PLANNING COMMISSION STAFF REPORT

MEETING DATE:	January 7, 2021
PROJECT NUMBER:	S-20-002
REQUEST:	Final Plat approval for a plat amendment subdividing an existing lot in the Crossing at South Salt Lake Subdivision into 2-lots
ADDRESS:	2150 South State Street
PARCEL NUMBER:	16-19-103-023-0000
PROPERTY OWNER:	Boyer South Salt Lake Crossing 2, LC.
APPLICANT:	Raising Cane's Chicken Fingers Restaurant

Figure 2: Existing and Proposed Lot Lines

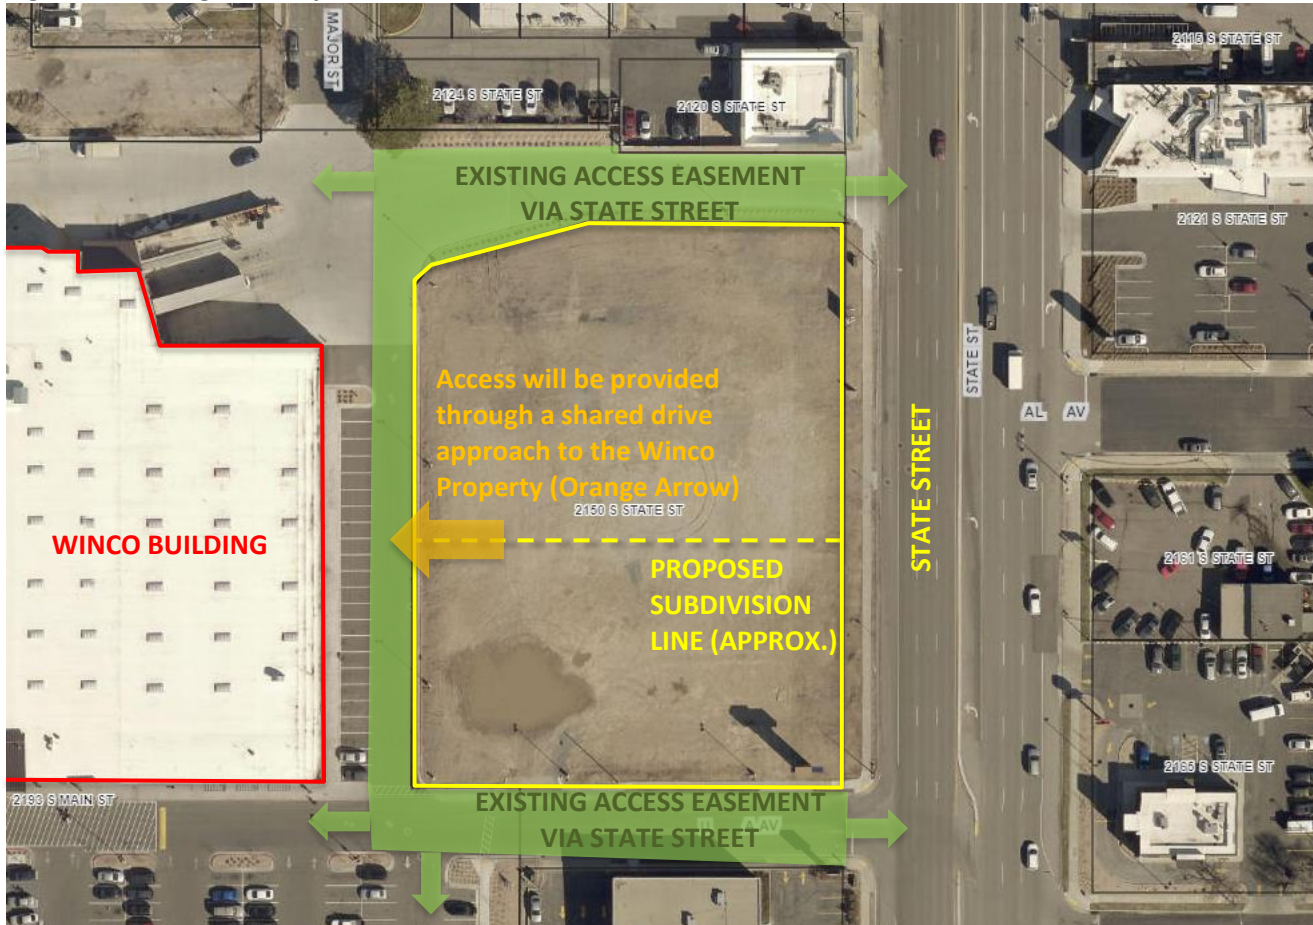
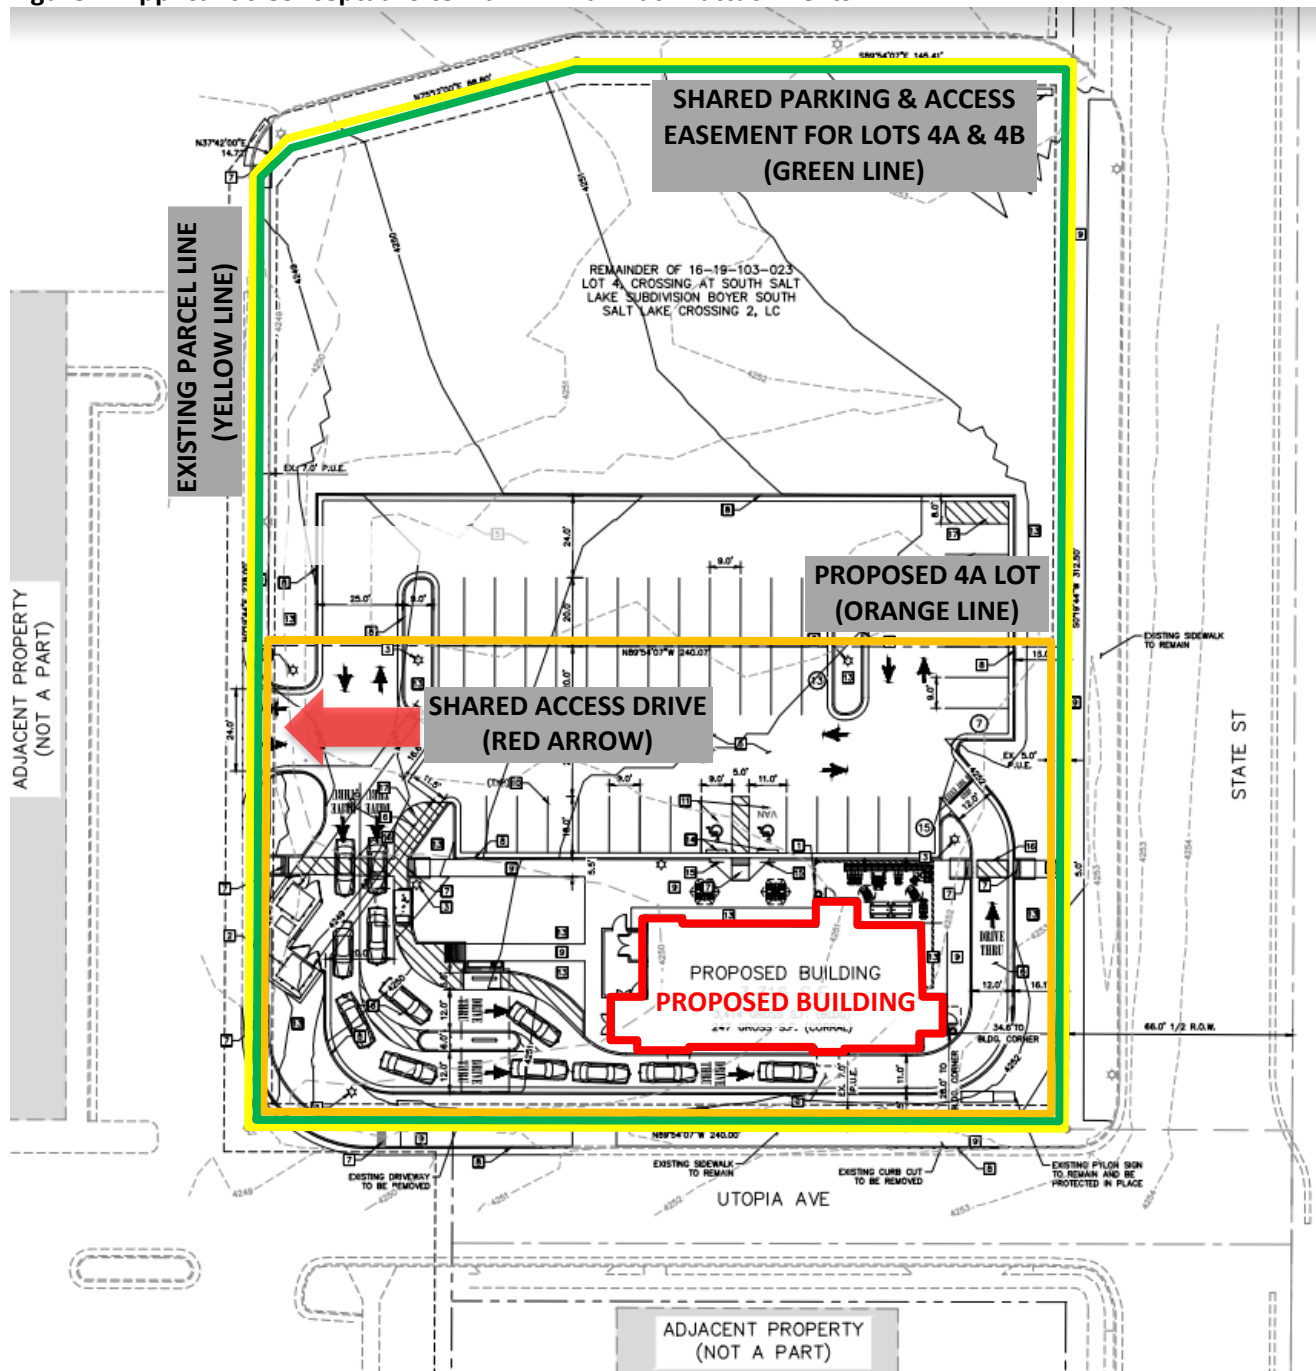
I. Double frontage lots	Not Applicable	
J. Multiple building yard areas	Not Applicable	
K. Side lot lines shall be at right angles to street lines	Complies – The newly created side lot line is at a right angle to street lines. Existing lot lines at the northwest corner of Lot 4B do not meet this requirement but will remain as part of this subdivision. No modification of existing lot lines is required.

M. Depth and width of properties shall be adequate to provide for off-street parking and loading facilities	Complies - Preliminary site plan and subdivision provides adequate off-street parking. At least 18 stalls are required and 29 stalls will be provided. The intent is for lot 4A and 4B to share parking. Any future use and development on lot 4B will need to comply with required parking.

P. Driveways shall be designed and arranged to avoid vehicles backing onto Streets	Complies –No changes are proposed to existing access points onto State Street. No direct access will be permitted from Lot 4A or Lot 4B onto State Street. Access will come from the drive aisle immediately to the west, and adjacent to the WinCo Store via two existing access points onto State Street. An existing easement grants access to existing thoroughfares. No driveways or parking stalls back onto public streets.

1. The applicant will continue to work with City staff to make all technical corrections necessary prior to recording the plat;
2. Prior to plat recordation and any additional development of the subsequent lot, the applicant must provide city staff the final plat mylar to include notarized signatures of owners' consent to dedication; obtain signatures of all entities indicated on the subdivision plat attached hereto;

5. The plat shall provide 10 foot public utility easements on all existing and proposed utilities;
6. The development of lot 4A shall be limited to one standalone restaurant structure. Due to sewer capacity, no other land use is approved with this petition. If the proposed development of Lot 4A falls through, the subdivision approval is null and void.

10. The proposed building shall be constructed according to South Salt Lake commercial design standards;
11. The applicant shall provide on the plat a reciprocal parking and access easement on the entirety of lots 4A and 4B granting shared parking between the two lots and their respective owners and occupants;

12. The applicant shall provide on the plat an access and circulation easement to allow access to Lot 1;
13. All items of the staff report.
